From: [Elnaz Mokhtari](#)
To: **S.33(1)**
Cc: [Hector Catalogna](#); [Stephen Muldoon](#)
Subject: RE: 42 James Street, Northcote, New Revision for Geotechnical Report (281686)
Date: Friday, 16 December 2022 12:25:24 PM
Attachments: [image003.png](#)
[image004.jpg](#)
[image005.jpg](#)
[image006.jpg](#)
[image007.png](#)
[image008.png](#)
[image009.jpg](#)
[image010.jpg](#)
[S44580_281686_IFC - Total.pdf](#)
[2201223-FEATURE.pdf](#)
[2201223-FEATURE.zip](#)

Please find attached a preliminary copy of the Civil Longitudinal section for the proposed spoon drain for the permanent batter for the land behind 42 James Street in Northcote. I have issued these for your review and comment.

PERMANENT BATTER REINSTATEMENT DETAIL

DESIGNED	EM	DRAWN	EM
CHECKED	HC	No. OF SHEETS	
SCALE	NTS @ A1	DATE STARTED	
SITE ID & JOB No.	S44580-281686	REV.	
DRAWING No.	S10		B

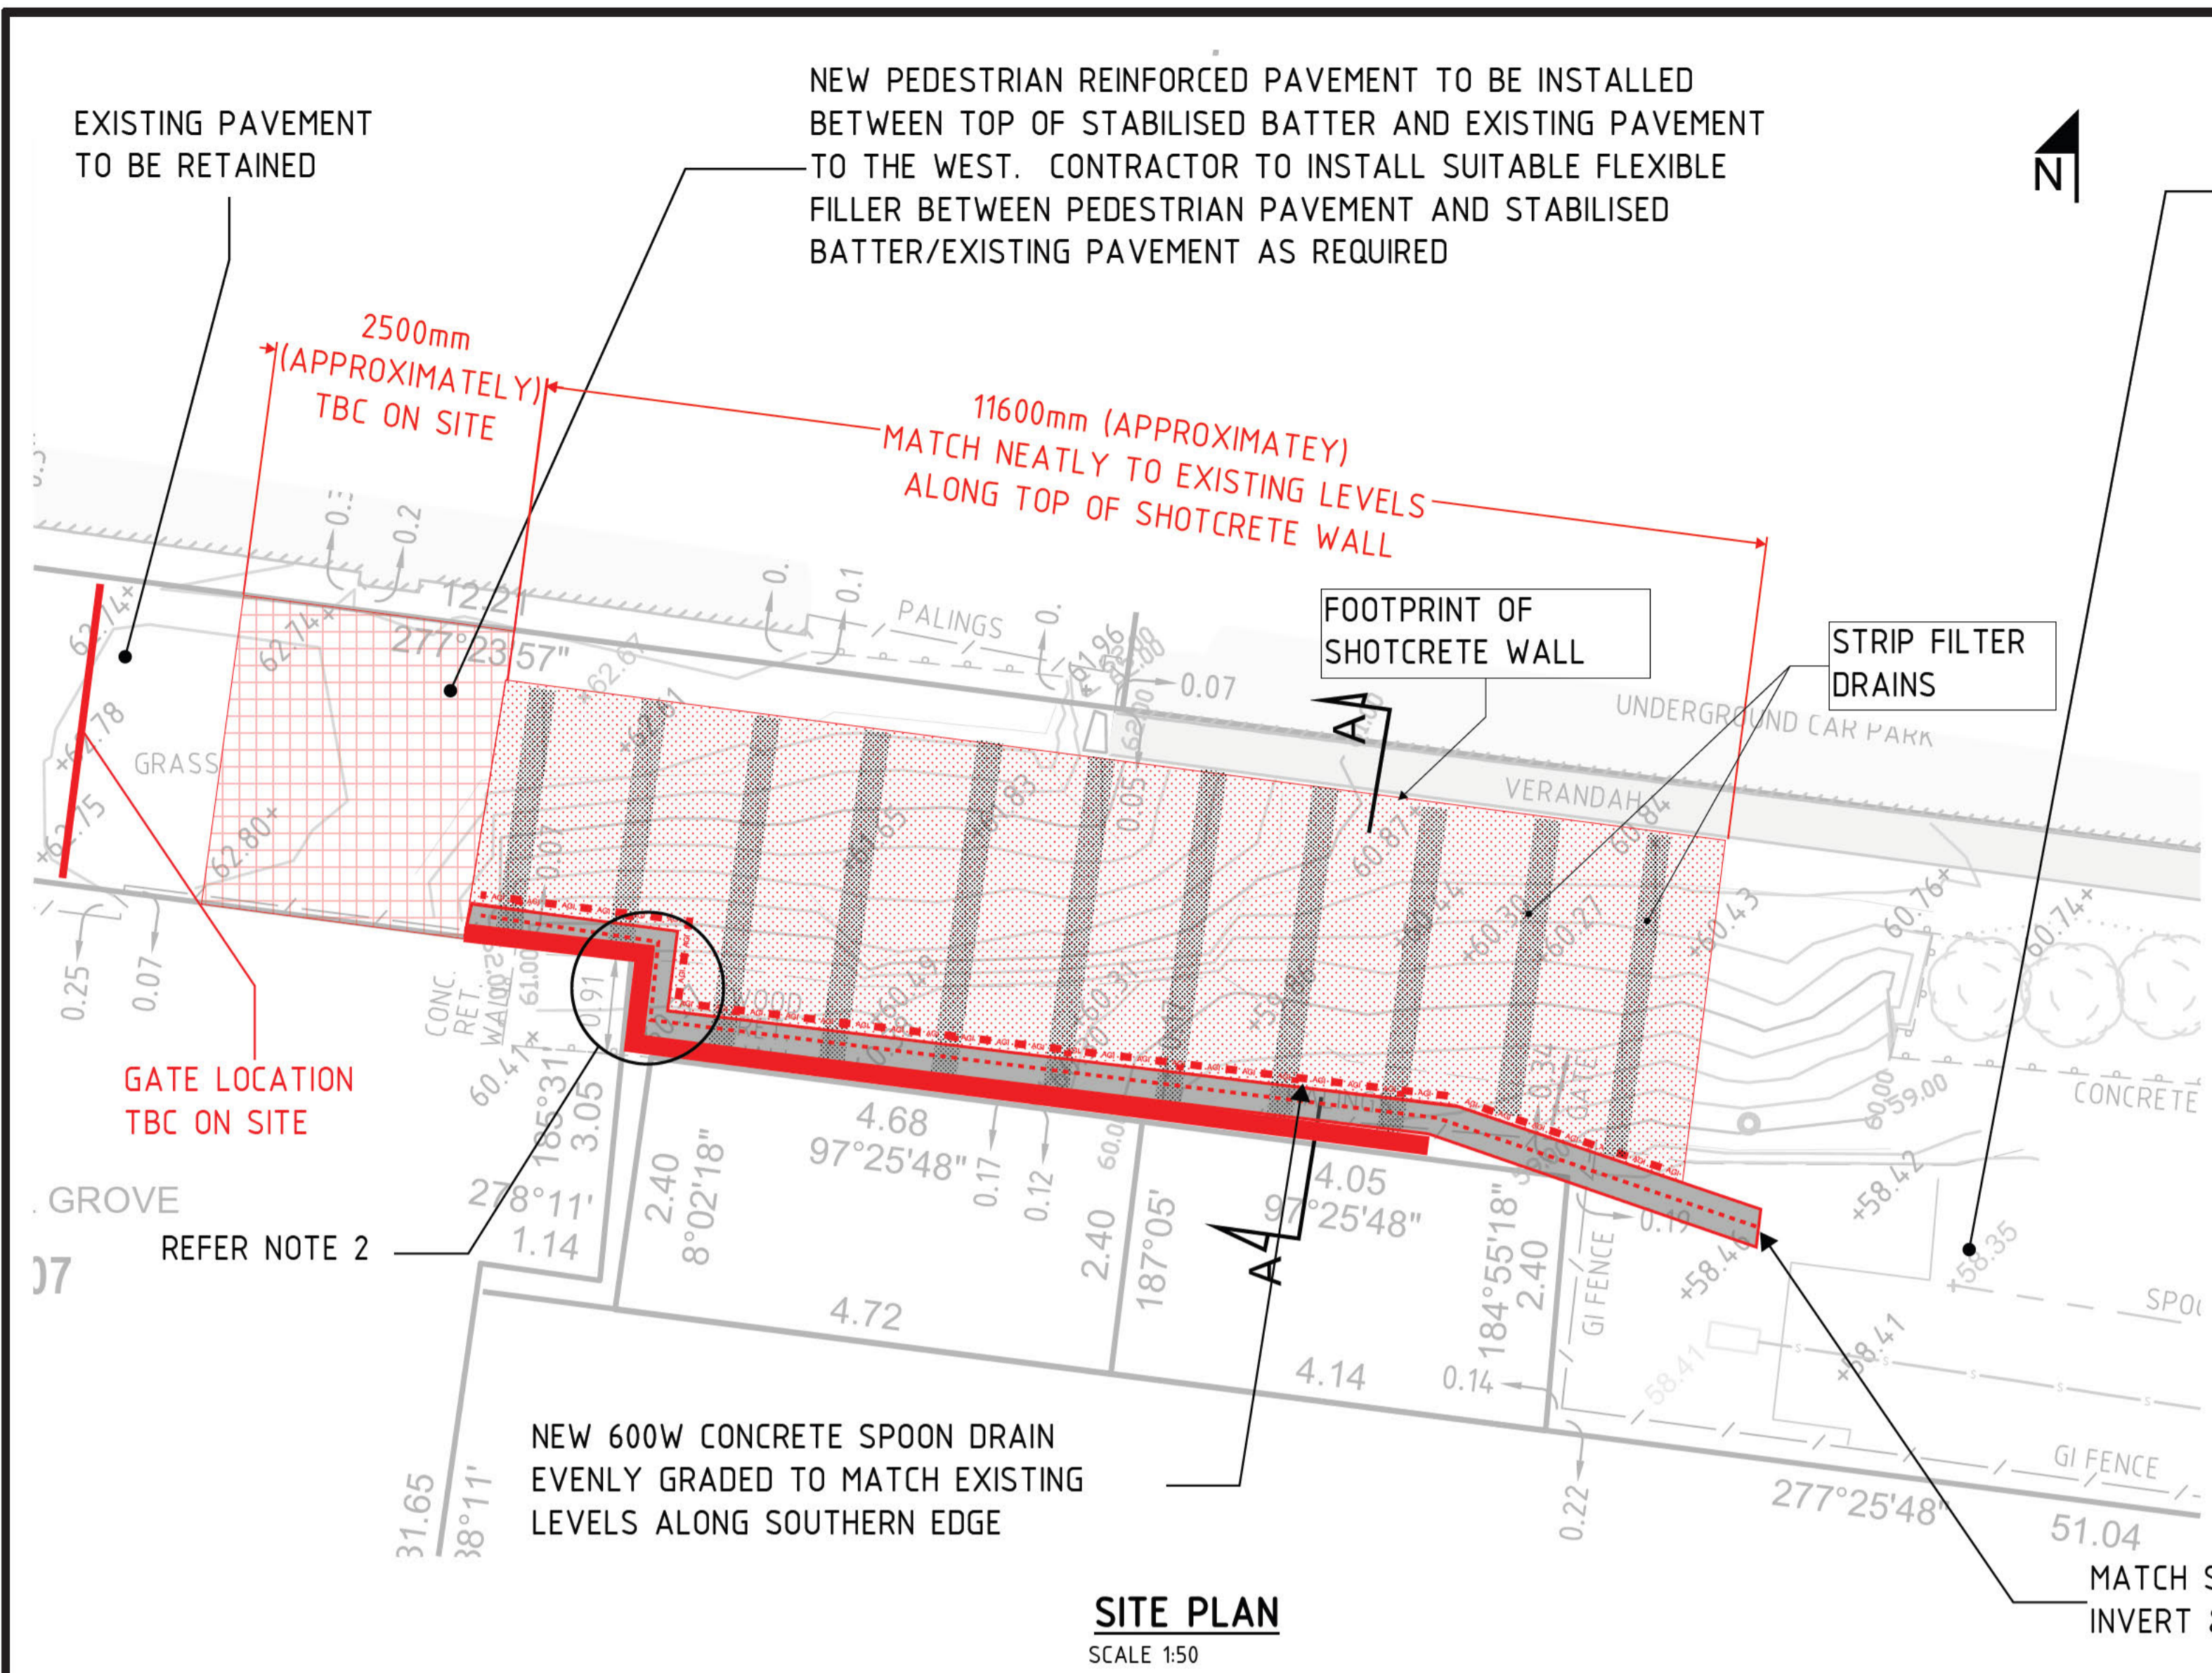
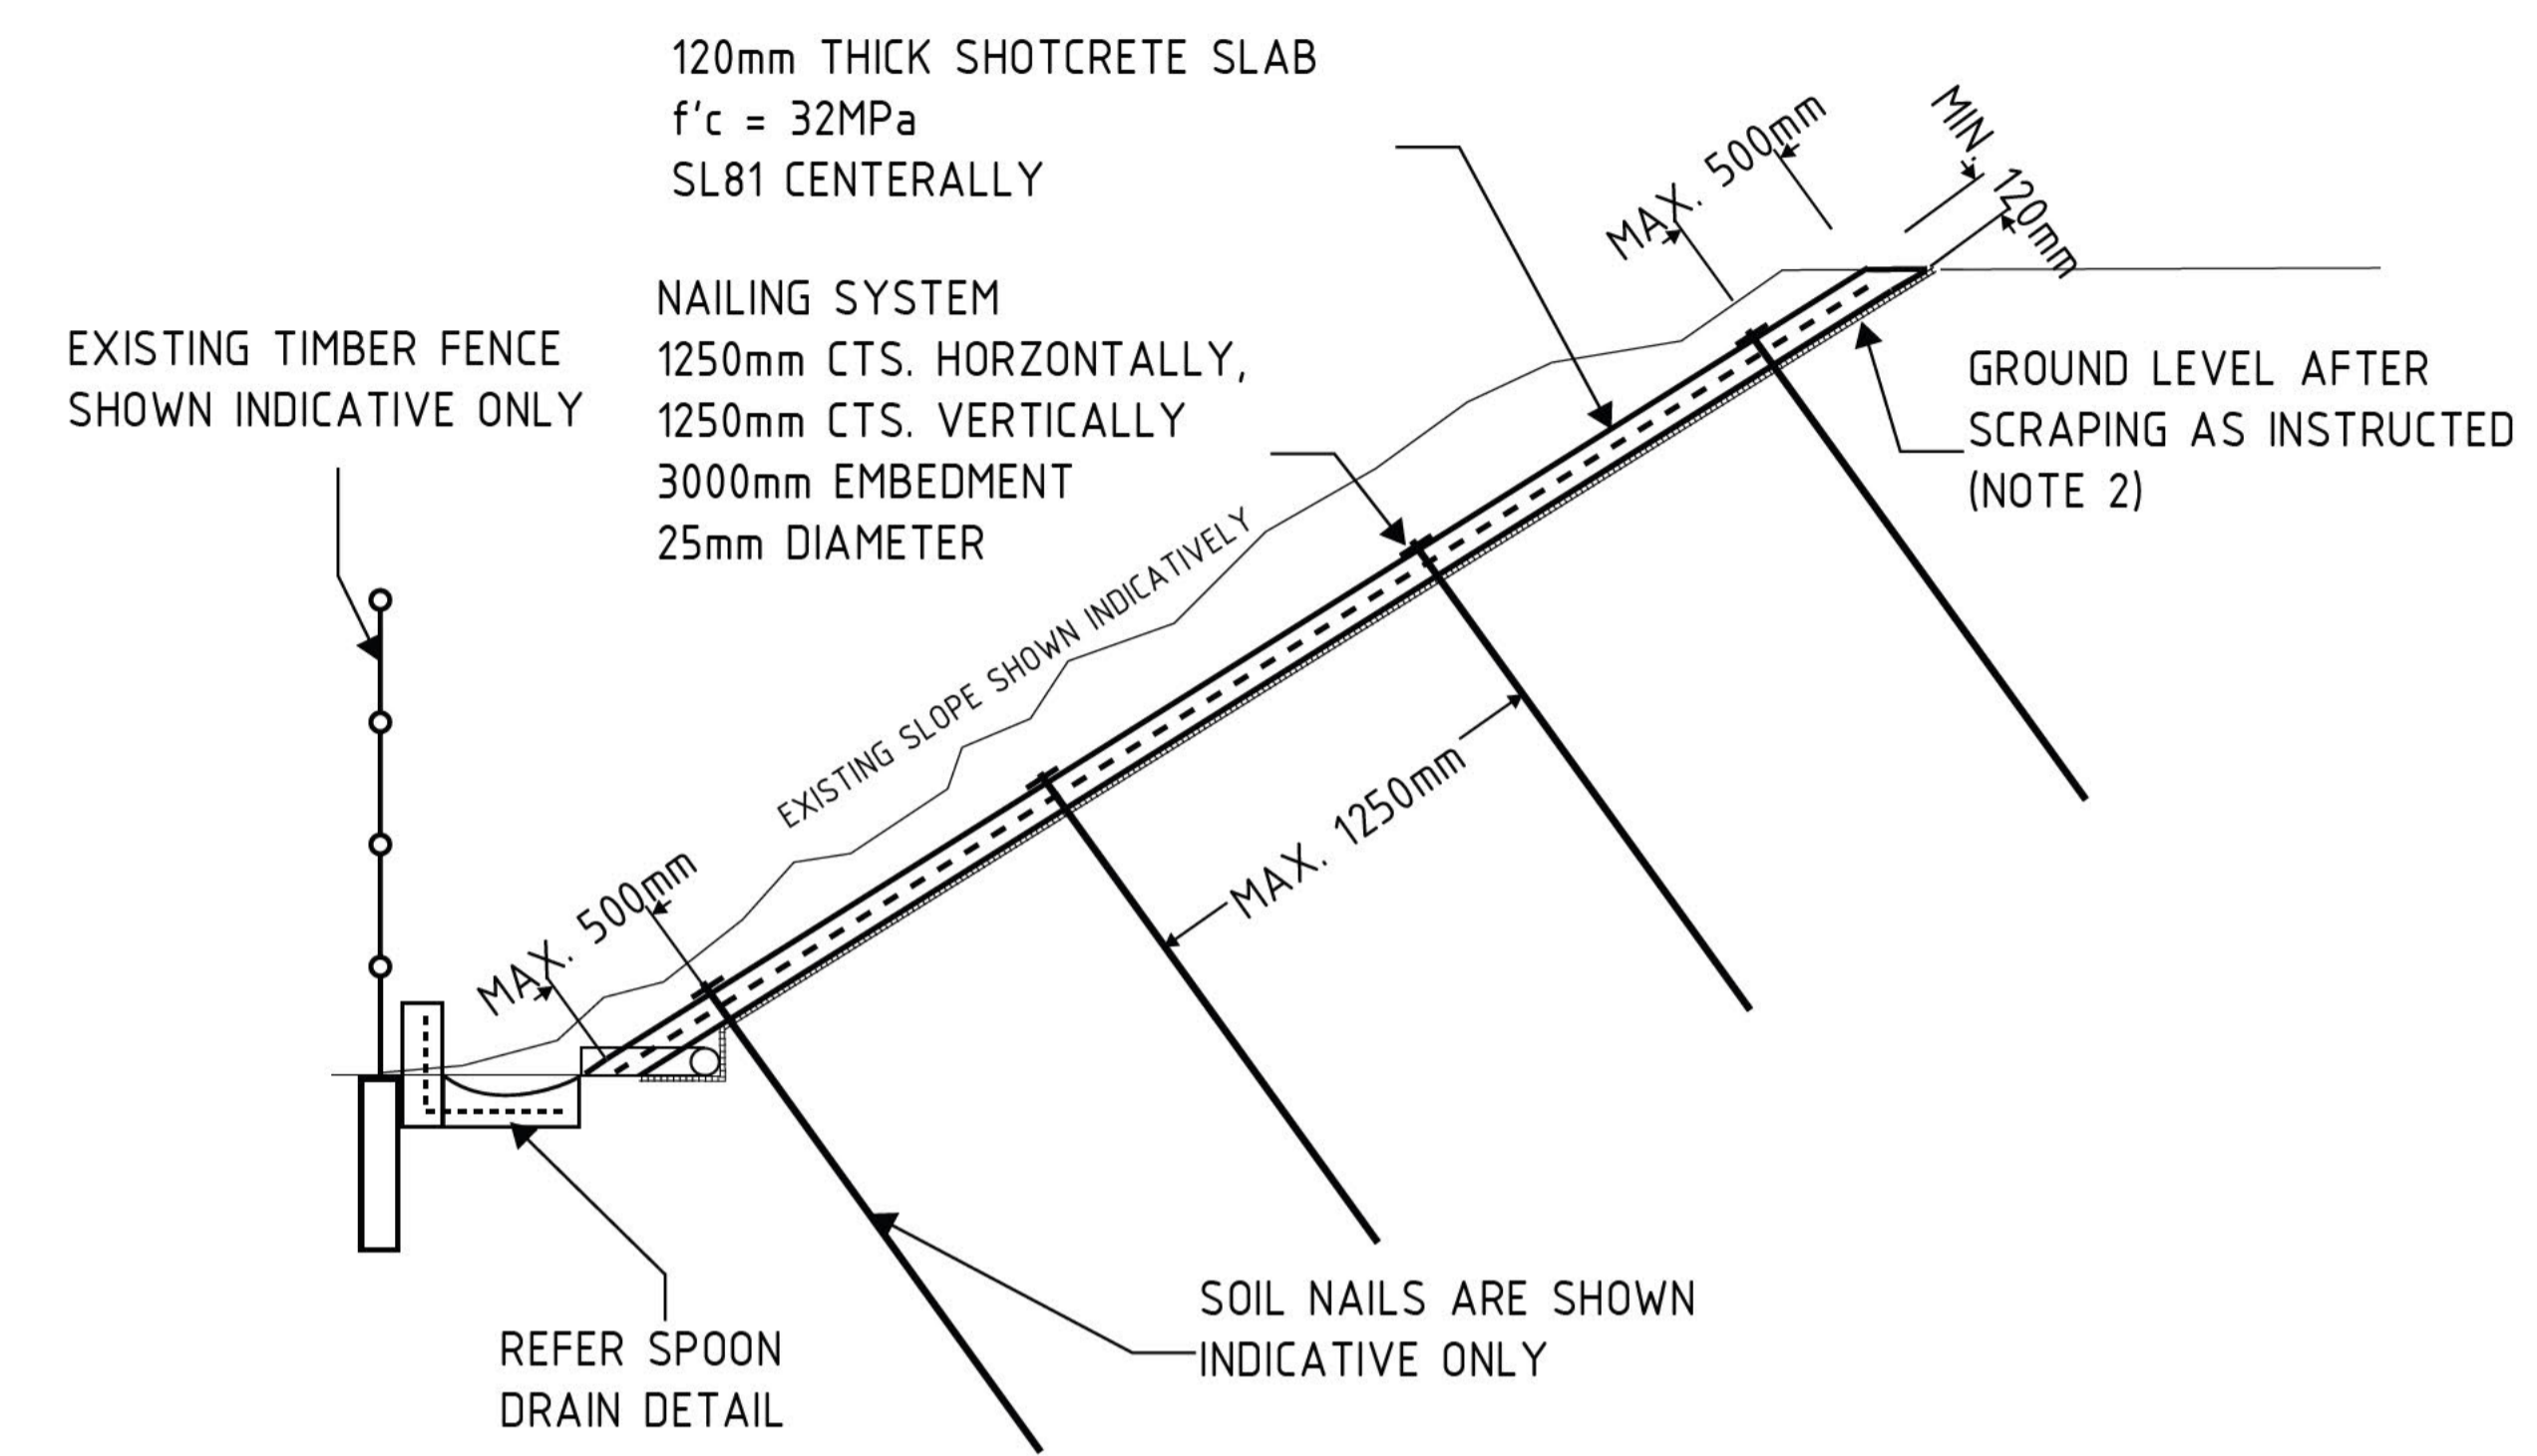
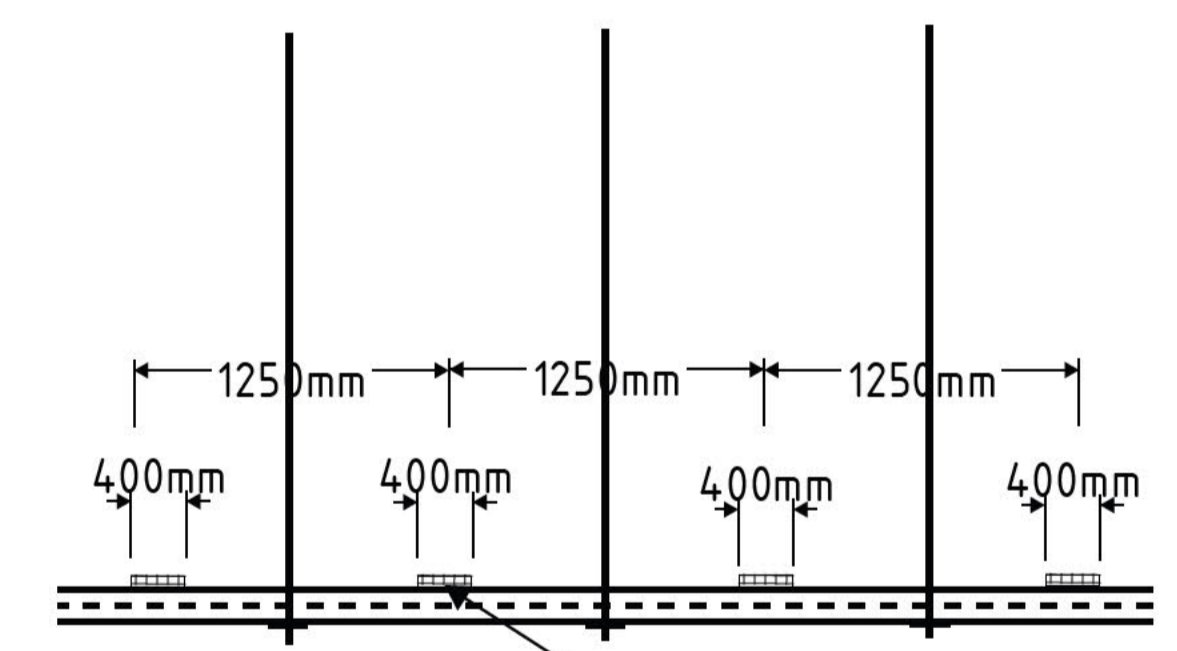
1. The design for the spoon drain from CH 0.000 to CH2.203 looks too steep (almost 100%) and it doesn't look practical or constructible with two turns (90-degree). Is it compliant with Australian standards.

2. Check the possibility of replacing the spoon drain with a catch drain in the corner.

5. Fill area at CH1.18 to be compacted Class 3 20mm size crushed rock compacted in 150mm layers.
This note can be added on the Civil/Structural drawings as required.

6. Further detail to be provided on how the spoon drain will be treated at severe drop-off near 90-degree bend at the beginning – Is there a large amount of fill to be placed here? If not, is a spoon drain the best solution and have GP with a pipe? Need Long section design.

1. Extend the plan to the west to the existing gate and show the existing concrete.
2. Detailed set out to be provided including Chainage and set out levels.
3. Long section design to be provided including Chainage, existing levels and proposed levels – design line/levels of the invert of proposed spoon drain and north building line should be both shown on LS design
4. Show width on Section A-A
5. A higher kerb, say 200mm, may be required adjacent to the spoon drain
6. Further detail to be provided on how the spoon drain will be treated at severe drop-off near 90-degree bend at the beginning – Is there a large amount of fill to be placed here? If not, is a spoon drain the best solution and have GP with a pipe? Need Long section design.
7. For the cost estimate, allow for clean up and trim trees east section of right of way in the schedule.

5. A section to show the levels after completion of work and where the slope meets the ground.

8. The footprint of the new slab needs to be shown on a Plan view, where is it in relation to fences and verandah etc?

9. A strip drain needs to be shown on the Plan view (around the perimeter)

Whilst the beginning of the spoon drain is relatively steep, it is only for a small section of the spoon drain and therefore won't be capturing a significant amount of water runoff. FMG have also provided a barrier kerb to one side, and the shotcrete wall provides a barrier on the other, therefore runoff will be wholly contained in the "channel" created by the spoon drain. We note that the layout/design may fall outside the Australian standards, however, it is a best practice response to manage stormwater within the constrained environment of the subject site.

FMG have some concerns with this proposal, in particular, where this drainage pit would discharge to, construction of a drainage trench prior to the shotcrete wall would also be considered very dangerous given the adjacent slopes and would require shoring etc. It is FMG's opinion that this is a costly alternative to pick up a small volume of surface water

- Runoff along Spoon drain will be constrained by the upright kerb on one side, and shotcrete on the other, effectively forming a 200mm high, 600mm wide channel. This is well over capacity and should not present any issues conveying flow. FMG could add a note identifying for the spoon drain to be “streamlined” on site at bends to ensure free drainage.

Refer plan

Refer plan
